## **WIND INDUSTRY COMMENTS ON RETI DRAFT PHASE 1B REPORT**

**Submitted by Dariush Shirmohammadi and Faramarz Nabavi  
RETI Wind Industry Representatives**

**November 20, 2008**

## APPENDIX C: CABAZON MAP

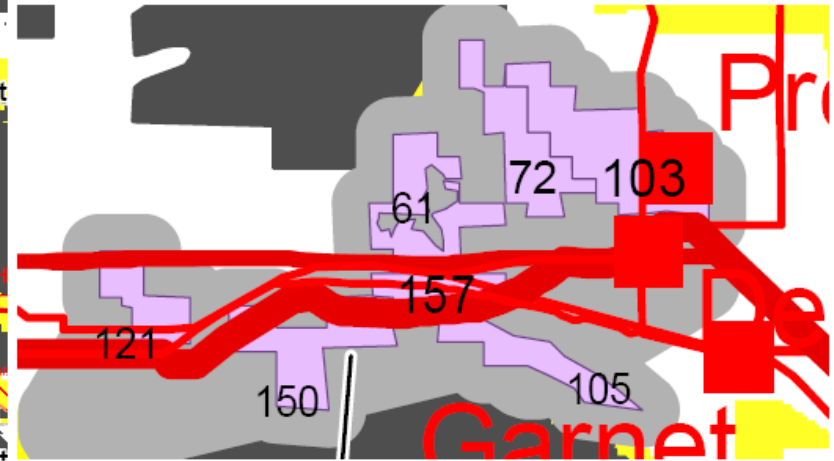
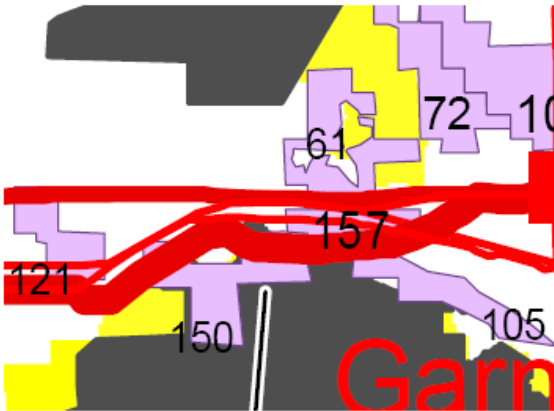
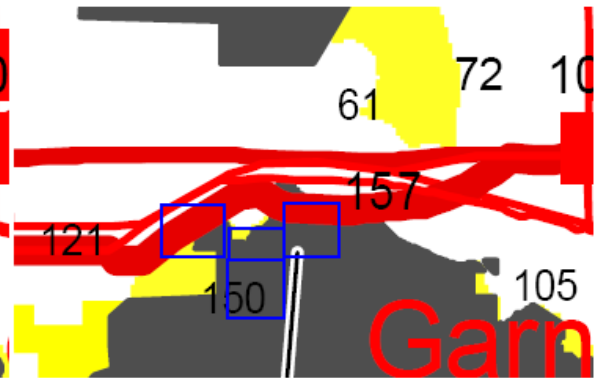
##### **2. Correct blackout designation on exclusion map**

The Cabazon Wind Energy 150-MW wind project area near Cabazon/Palm Springs is private land within the bounds of the Santa Rosa and San Jacinto Mountains National Monument. Although B&V has included the project in its assessments and the project is shown within a CREZ, the area is inaccurately portrayed as a “blackout” exclusion area on the layered RETI maps. It is very important to the project developer that this land not be shown as a blackout area so that the public is not misled as to the status of the land.

Appendix C is a map showing the land area at issue. The private land area should be shown as a “white” area in all maps where blackout areas are shown. Alternatively, all maps showing this land as a blackout area should include a note stating:

“Some areas indicated as Environmental Blackout Areas in the Santa Rosa and San Jacinto Mountains National Monument are, in fact, private property exempt from monument status. (Public Law 106–351—Oct. 24, 2000 Santa Rosa and San Jacinto Mountains National Monument Act of 2000 114 Stat. 1364 Public Law 106–351—Oct. 24, 2000).”
